**VCSNS Units 2 and 3 COL Application**

**COLA Revision 1 - Part 13 Reviewer Aid**

Title: South Carolina Electric & Gas Co.  
V. C. Summer Units 2 and 3 Quality Assurance Program Description

Document revised to incorporate RAI responses and changes to NEI 06-14A, Rev 6, dated November 2008.

Figure II.1-1 SCE&G Organization

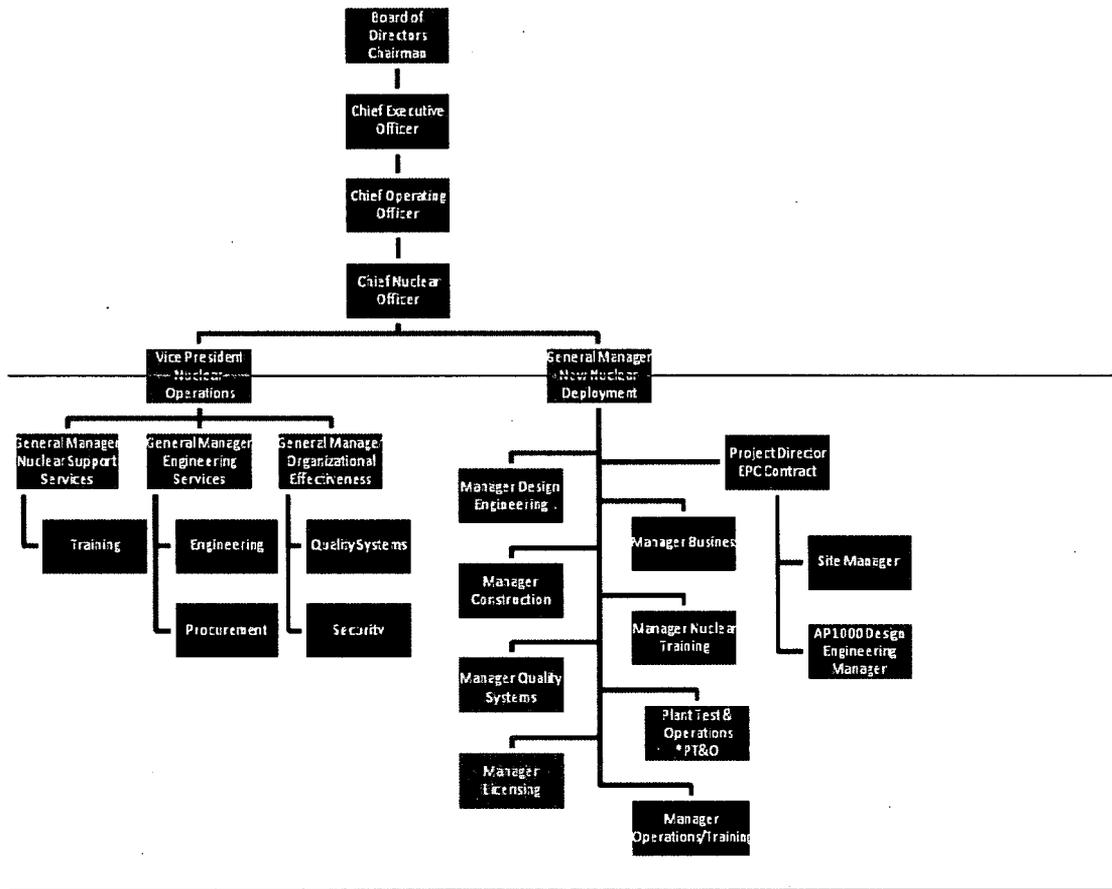
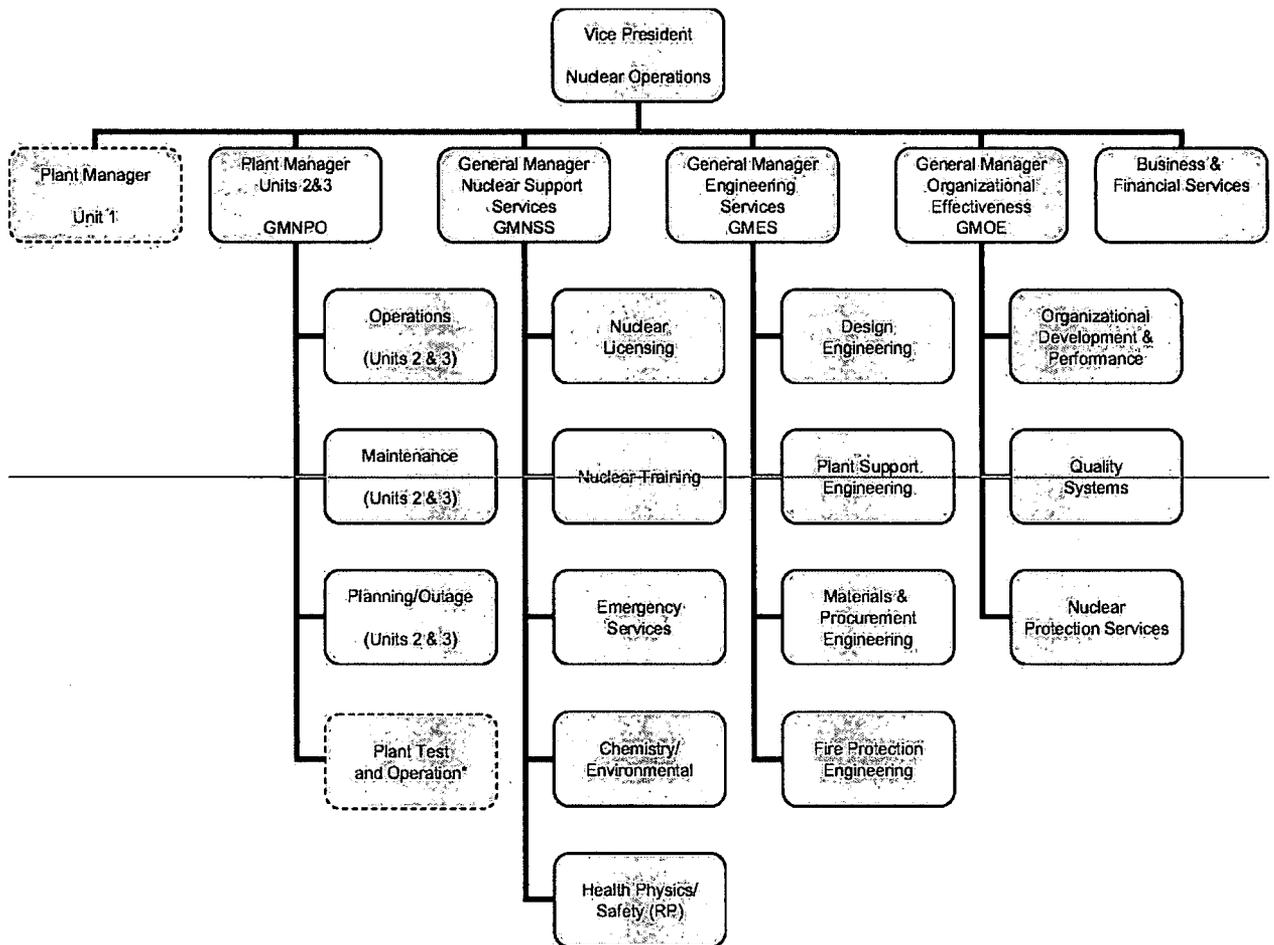
The following sections describe the reporting relationships, functional responsibilities and authorities for organizations implementing and supporting the NND QA Program. The SCE&G ~~e~~Organization and the ~~NND-Plant Management e~~Organization are shown in Figures II. 1-1 and II. 1-2, respectively.
